Subject: Indian Point 3 Nuclear Power Plant
Docket No. 50-286
Control of Heavy Loads Review - General
Requirements for Overhead Handling Systems

CONTROL OF HEAVY LOADS

POWER AUTHORITY OF THE STATE OF NEW YORK
INDIAN POINT 3 NUCLEAR POWER PLANT
DOCKET NO. 50-286
JUNE 22, 1981

RESPONSES TO REQUESTS
FOR
INFORMATION IN SECTION 2.1
OF ENCLOSURE 3 TO JULY 31, 1980
LETTER - EISENHUT TO BERRY

FIGURE 3

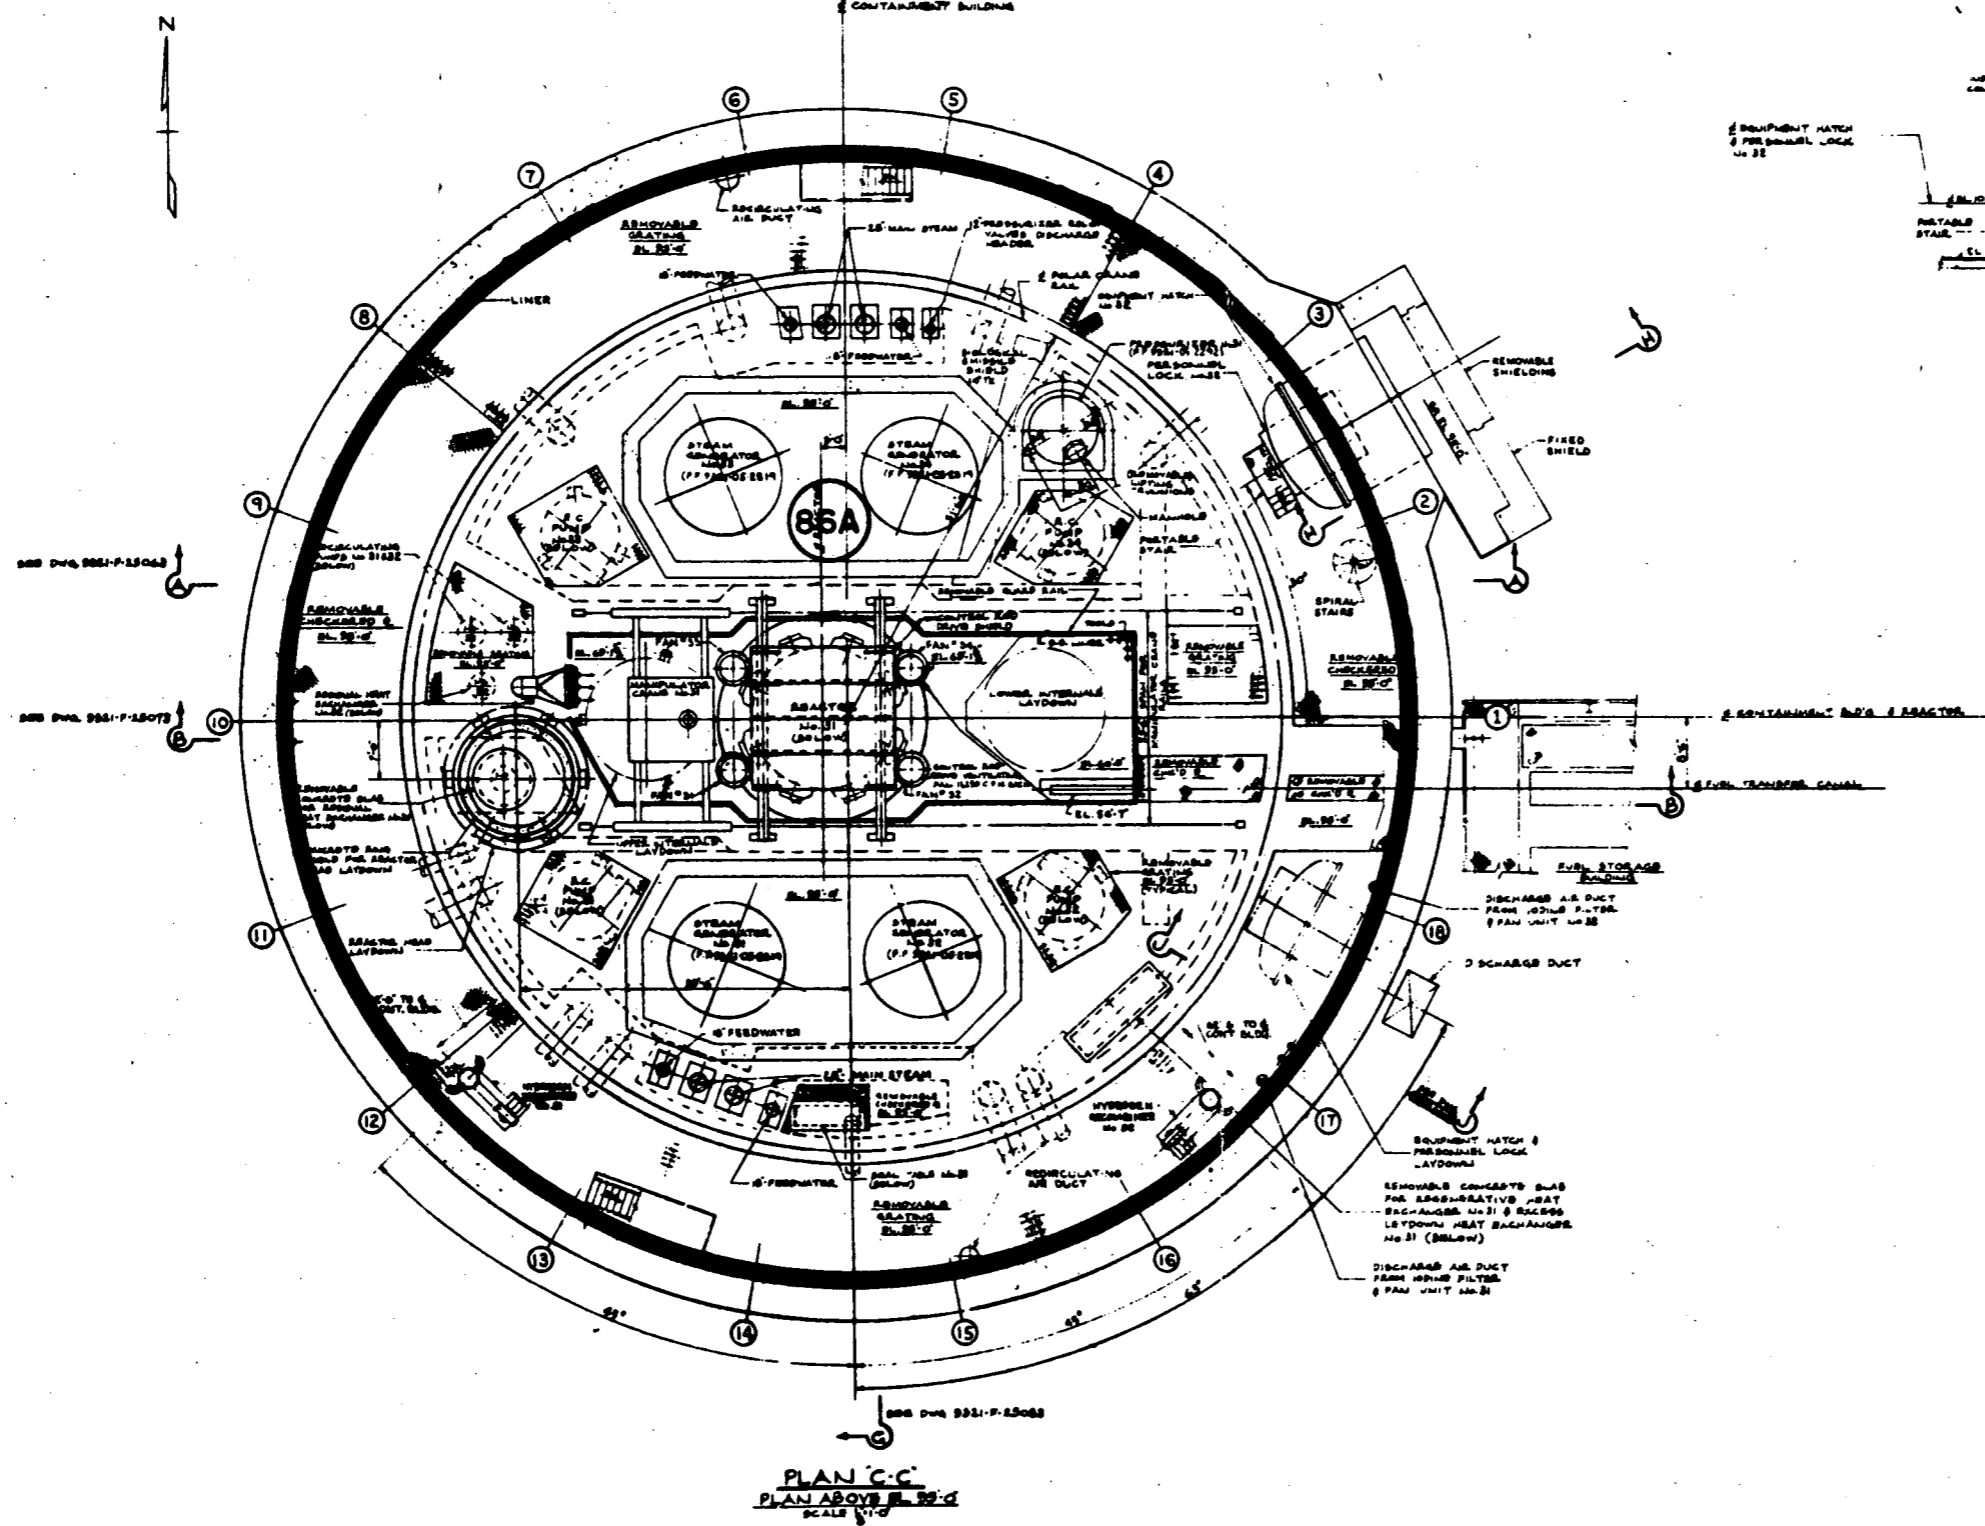
- a. Drawings or sketches sufficient to clearly identify the location of safe load paths, spent fuel, and safety-related equipment.
- b. A discussion of measures taken to ensure that load-handling operations remain within safe load paths, including procedures, if any, for deviation from these paths.

RESPONSE: Containment - The containment is served by a Polar Gantry Crane supported on rails on the crane wall at the operating floor level (95' elevation). This crane was designed by Whiting Corporation and possesses a 175 ton main hoist and a 35 ton auxiliary hoist. The heavy loads that are periodically handled by the Polar Crane are identified in Table I of the response to 3.c. below. Figure 3 shows the general layout of equipment inside containment. The operating procedure for the Polar Crane defines two areas over which loads are not to be carried except under certain situations. Area 1 is over the reactor vessel. With the exception of the reactor vessel head, the upper internals and the reactor vessel weld ISI inspection tool, no heavy loads are permitted to be carried over Area 1 when the reactor vessel head is removed. This restriction includes the Polar Crane main and auxiliary hoist load blocks.

FIGURE 5
 REACTOR HEAD LIFTING RIG

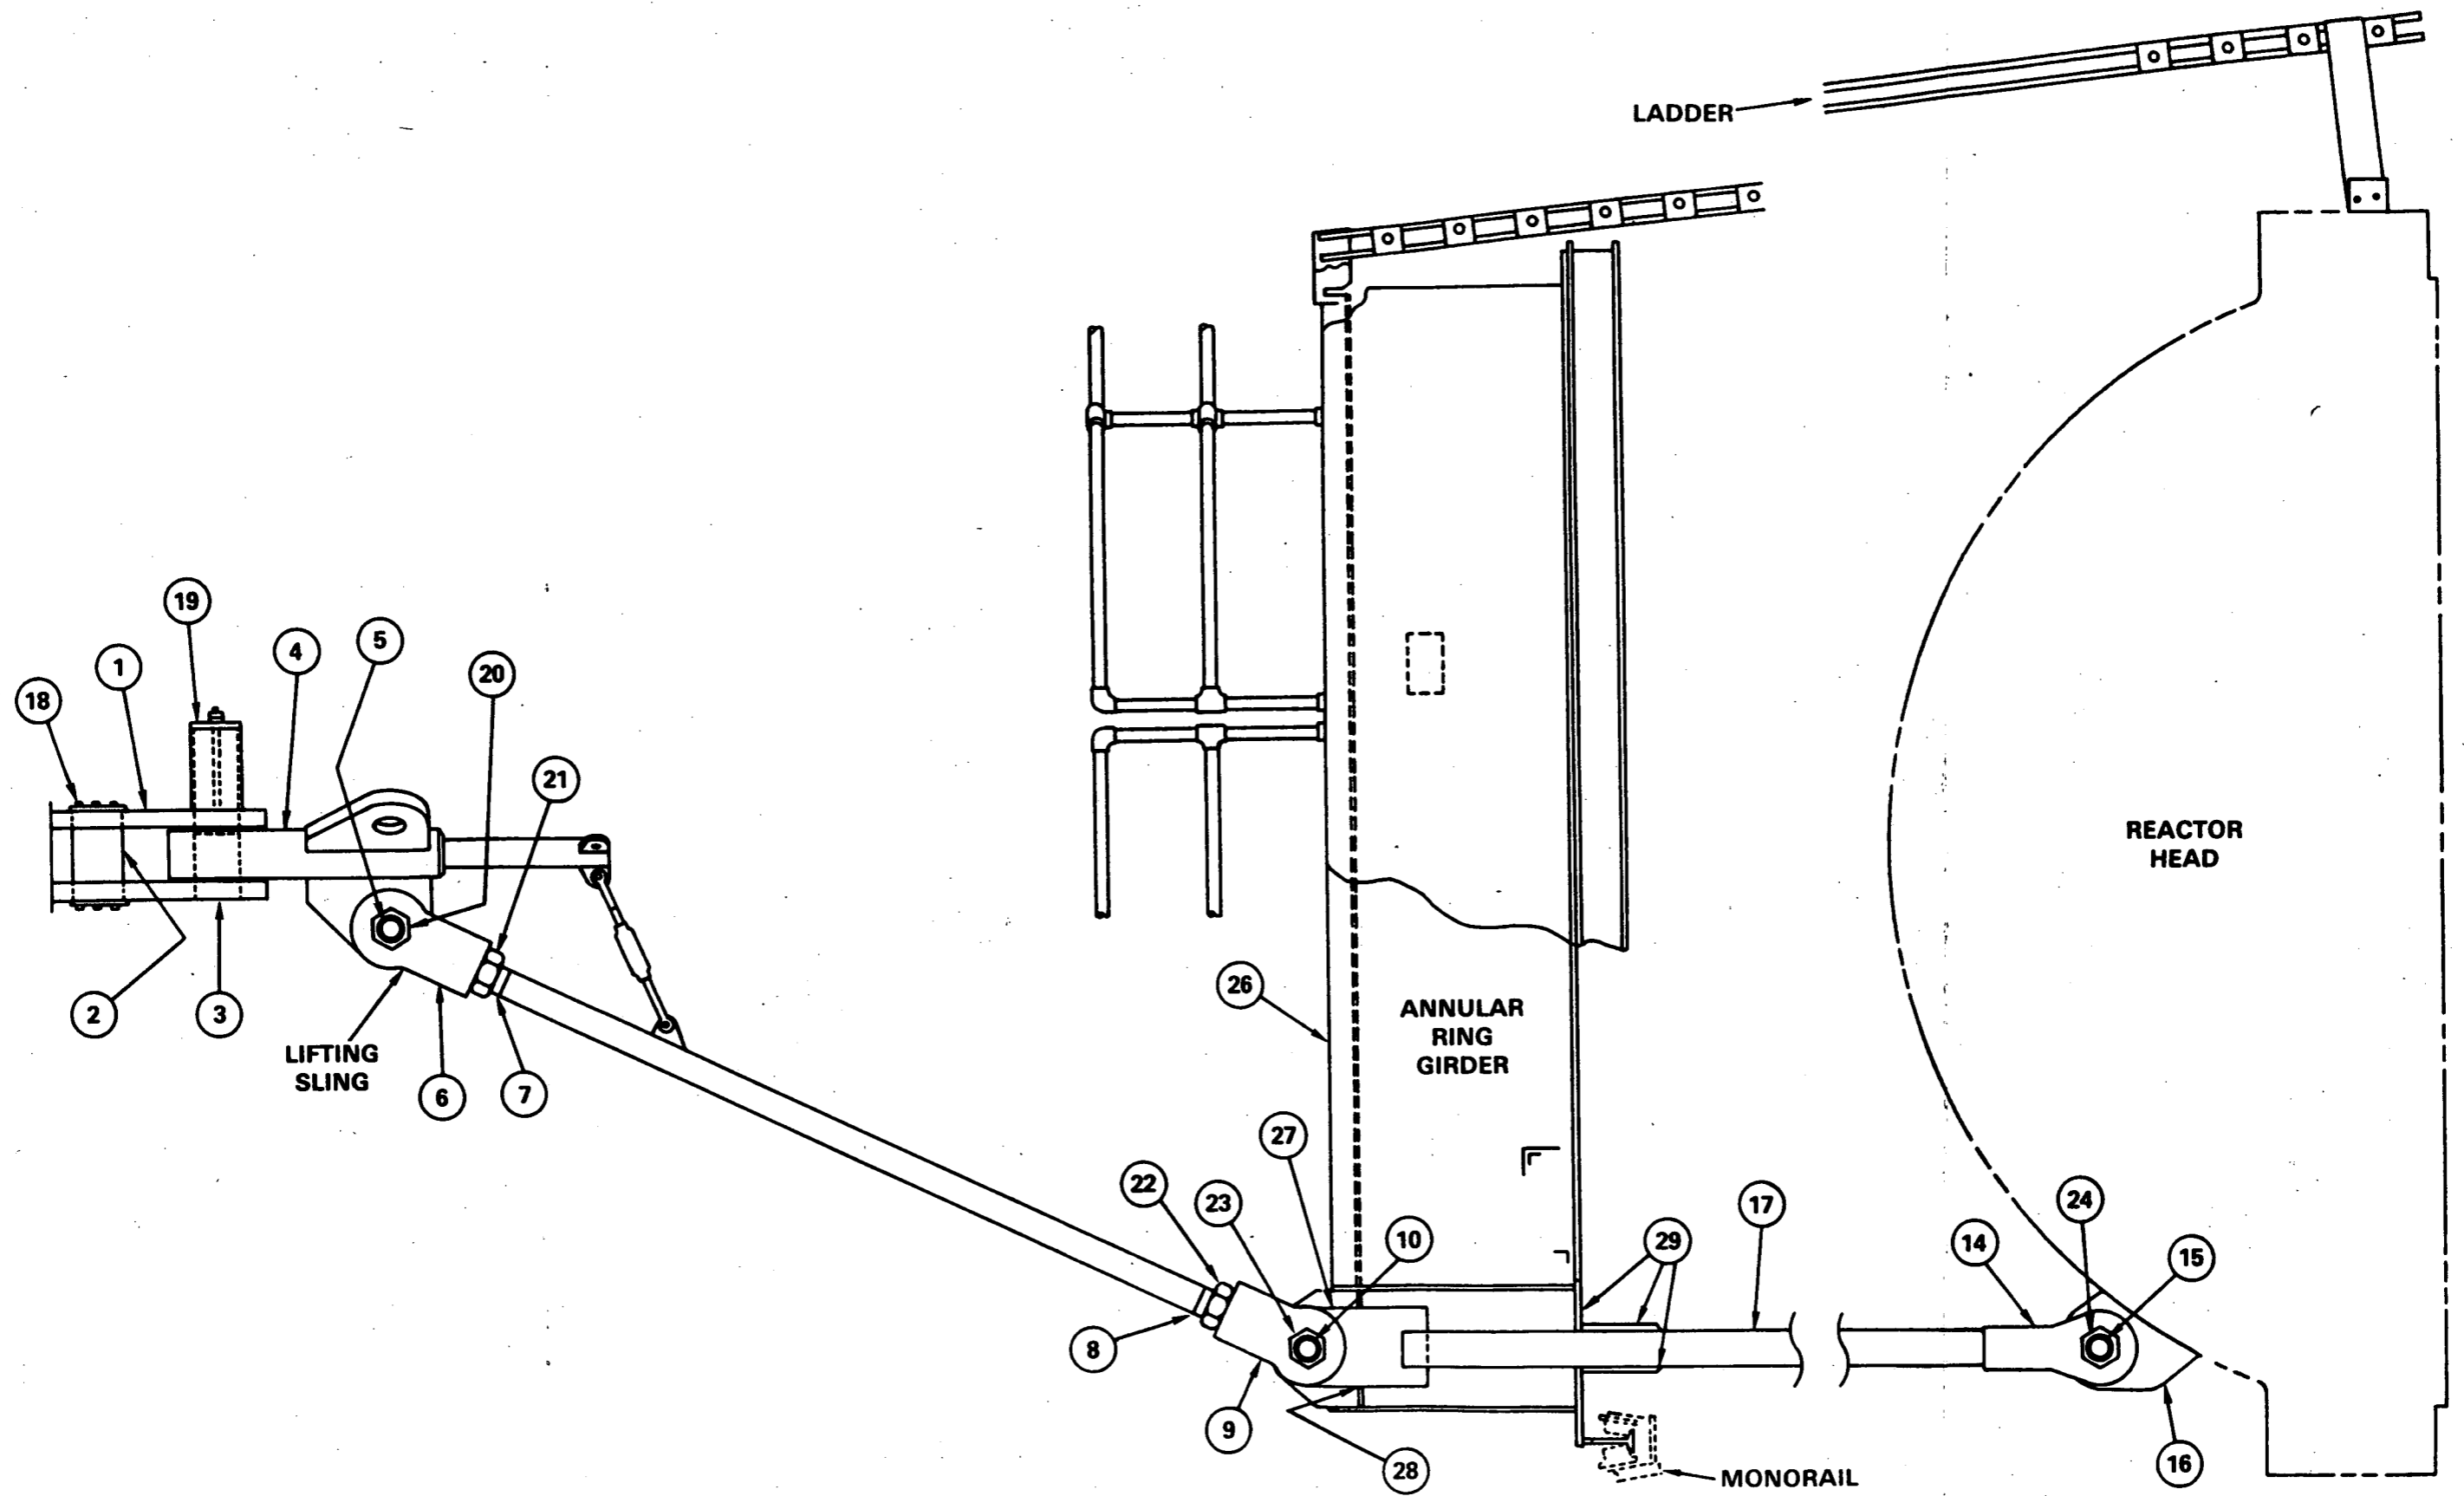
The Reactor Head Lifting Rig (Figure 5) consists of a welded and bolted structural steel frame with rigging for removal and storage of the reactor head. The device, an annular ring girder, is left attached at all times to three lifting lugs, which are an integral part of the reactor head. The three leg assemblies are pinned to the lugs and held fastened by a jam nut. They extend vertically upward and pass through the girder and a circular platform assembly to which they are braced and welded. A removable handrail is placed around the outer periphery of the platform. A ladder hooked to the top of the platform assembly provides a means of access. Located around the outside bottom portion of the ring girder is an I Beam. This beam is positioned directly over the stud positions and three rail cars ride on it to support the three hoists that raise and lower the stud tensioners, while positioning them on the studs during refueling tensioning and detensioning. An adjustable tri-pod lifting sling is pinned to the hook of the crane and lowered over the platform assembly of the lifting rig. Each leg of the sling is attached to the top of the three legs of the lifting rig in the same manner as to the head (lifting lugs, pins and jam nuts). The lifting sling (tri-pod) is removed and stored on the head laydown pad on the operating deck when not in use.

Exception 5: As to the Reactor Head Lifting Rig and the Internals Lifting Rig, there are several components whose inspection in accordance with all of the requirements of 5.3.1(2) on an annual frequency is impractical. These components are those that require disassembly not normally performed or removal of protective coatings. The proposed inspections of all load bearing components and critical areas including exceptions for these rigs are indicated in Tables 4 and 5. The component numbers refer to those on Figures 5 and 6.

TABLE 4 - Reactor Vessel Head Lifting Equipment Inspection

NOTE: Dimensional examination of Items 4, 5, 6, 14, 15 and 16 which require disassembly shall be done at a five-year interval. Thorough visual examination shall also be conducted at a five-year interval (partial visual examination of exposed surfaces shall be conducted at the normal intervals). Examination of portions of threaded ends of Items 5, 7 and 8 that are not visible shall be conducted at a five-year interval.
